Standards Governing the Design of Curbside Mailboxes

ACTION: Notice of proposed revision of standards; invitation to comment.

SUMMARY: The Postal Service proposes to replace USPS STD 7B, which governs the design of curbside mailboxes, with new USPS STD 7C. The proposed new STD 7C was developed internally to meet the operational requirements of the Postal Service.

**LOCKED MAILBOX- MAIL SLOT DESIGN
(FULL SERVICE)
FIGURE 2A**

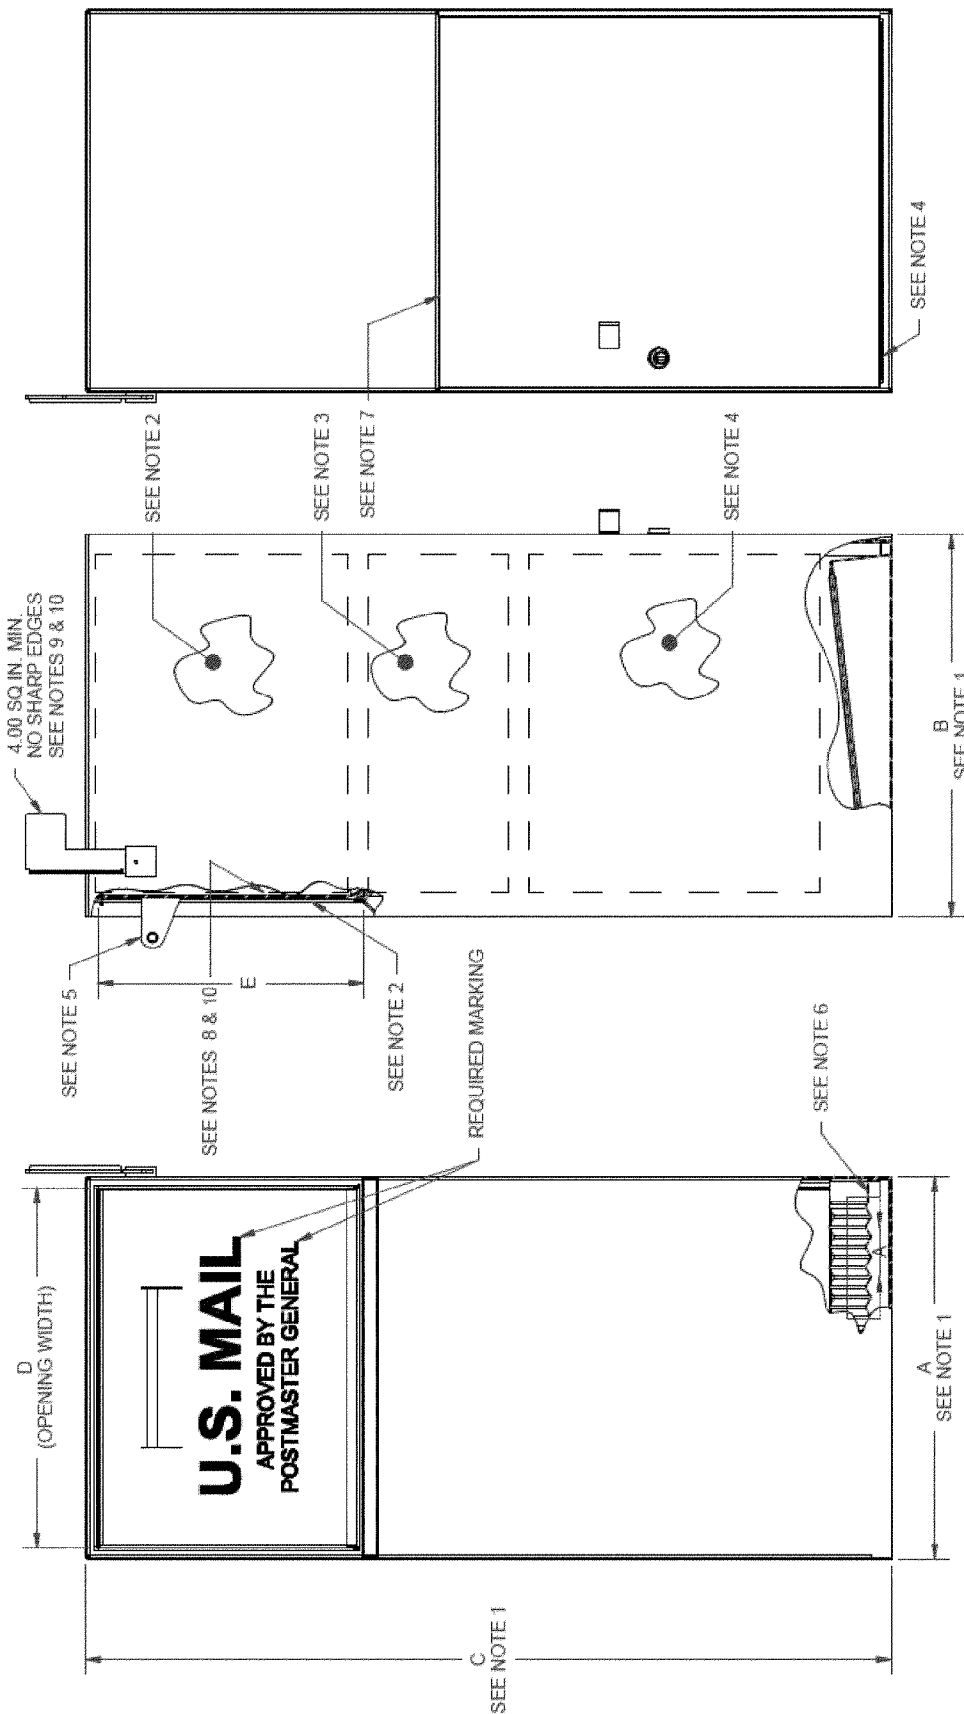
3.1.2.1.1 Full Service—Locked mailbox designs of this class allow for both incoming and outgoing mail as depicted in Figure 2A. Both incoming and outgoing mail functionality must be

located behind a single carrier service door as shown in Figure 2A. While it is preferred¹ that the outgoing mail function be handled via use of the backside of the front door, any alternate use of a separate outgoing mail compartment, such as beneath or side-by-side with the incoming mail compartment, is permitted provided that no additional carrier service is introduced. All designs must allow the carrier direct access to grasp and retrieve the outgoing mail.

LOCKED MAILBOX
(FULL SERVICE SHOWN)
FIGURE 3

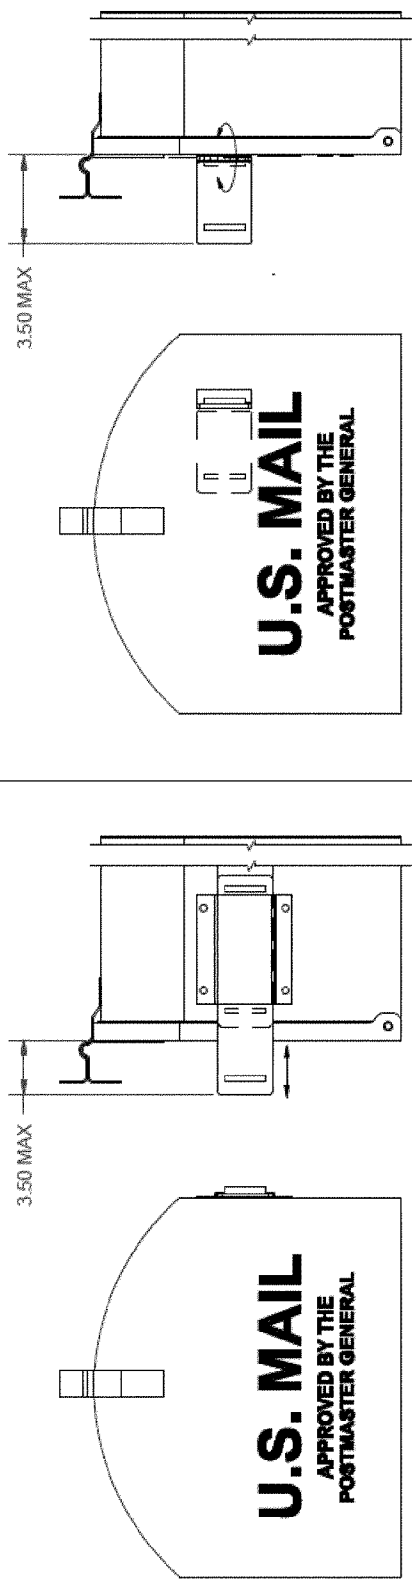
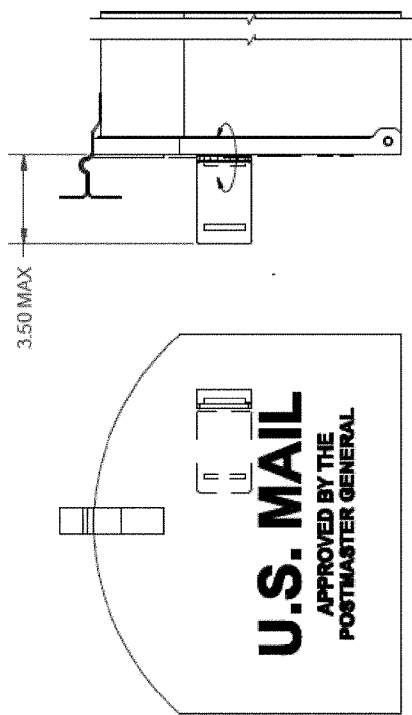
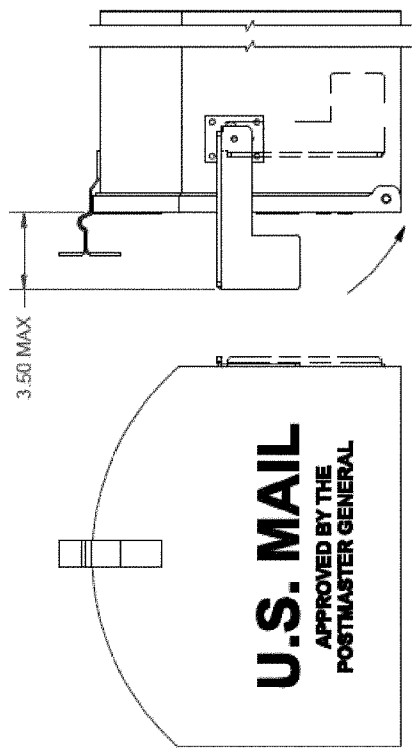
2. Adds new Figures 1B and 3 for the new enhanced capacity non-locked and locked mailbox design options. These figures provide overall design parameters for the two new mailbox design options and the figures are not mandatory design templates.

3.1.2.2.1 Full Service—Locked mailbox designs of this class allow for both incoming and outgoing mail as depicted in Figure 3. Both incoming and outgoing mail functionality must be located behind a single carrier service door as shown in Figure 3. While it is preferred¹ that the outgoing mail function be handled via use of the backside of the front door, any alternate use of a separate outgoing mail compartment, such as beneath or side-by-side with the incoming mail compartment, is permitted provided that no additional carrier service is introduced. All designs must allow the carrier direct access to grasp and retrieve the outgoing mail.

3.1.2.2.2 Limited Service—Locked mailbox designs of this class allow only for incoming mail. Refer to the two Locked mailbox feature exceptions linked to Note 10 of Figure 3.

DIRECTION OF LOADS
NON-LOCKED MAILBOX
(FULL SERVICE)
FIGURE 6

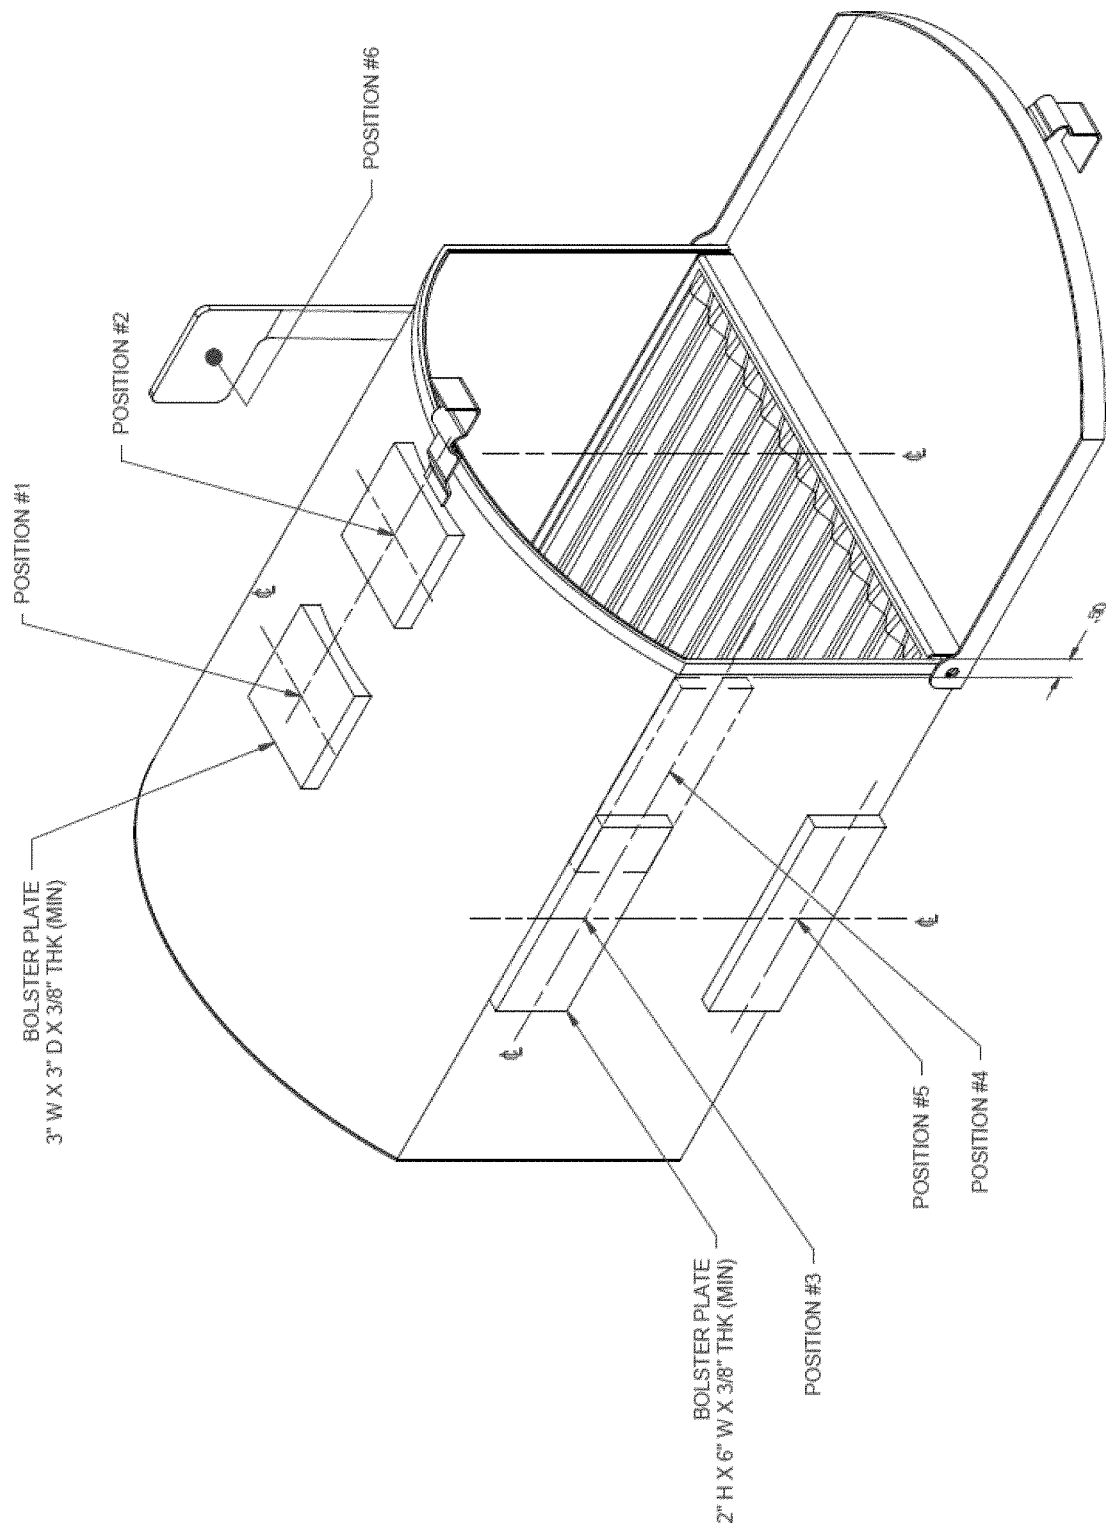
4.8 Structural Rigidity Requirements—Forces of specified magnitude (see Table II) must be slowly applied at specific points on the mailbox under test (see Figure 6). These forces must be held for a minimum of 1 minute and then released. After their release, the deformation caused by the forces must be measured. If the deformation exceeds the limit specified in Table II, the mailbox under test has failed to meet the structural rigidity requirement. The doors must remain closed for test positions 1 through 6. The forces at positions 1 and 2 must be applied with the mailbox in its normal upright position, supported by a horizontal board. The forces at positions 3, 4, and 5 must be applied with the mailbox lying on its side (flag side down). The mailbox must be supported, on the flag side, by a flat board that is relieved in the immediate area of the flag mechanism. The force at position 6 (Non-Locked mailbox flags only) must be applied with the mailbox lying on its side (flag side up). This load may be applied as shown in Figure 5 or from the other direction. If visible cracks in the material, develop as a result of the testing, the mailbox under test has failed to meet the structural rigidity requirement. At the conclusion of the Structural Rigidity testing, if the mailbox under test fails to operate normally, as defined by this document, the mailbox under test has failed to

4.9 Impact Test—Refer to Figure 6 for load positions. Precondition the mailbox for 4 hours at –20° Fahrenheit. The following testing must be performed within 3 minutes of removing the mailbox from the temperature chamber. At both load positions 3 and 4, with the mailbox lying on its side (flag side down) with all doors closed, apply an impact load force generated by a 10-pound weight dropped from a height of 3 feet above the mailbox surface onto a bolster plate having a surface not larger than 2 inches by 6 inches. The mailbox must be supported, on the underside, by a flat board that is relieved in the immediate area of the flag mechanism. If any noticeable perforation, occurrence of sharp edges, or cracking of the material (either inside or outside the mailbox) develops as a result of the impact, or if the door becomes inoperable or fails to close normally, the mailbox under test has failed to meet the impact resistance requirement. This test applies to all mailbox designs.
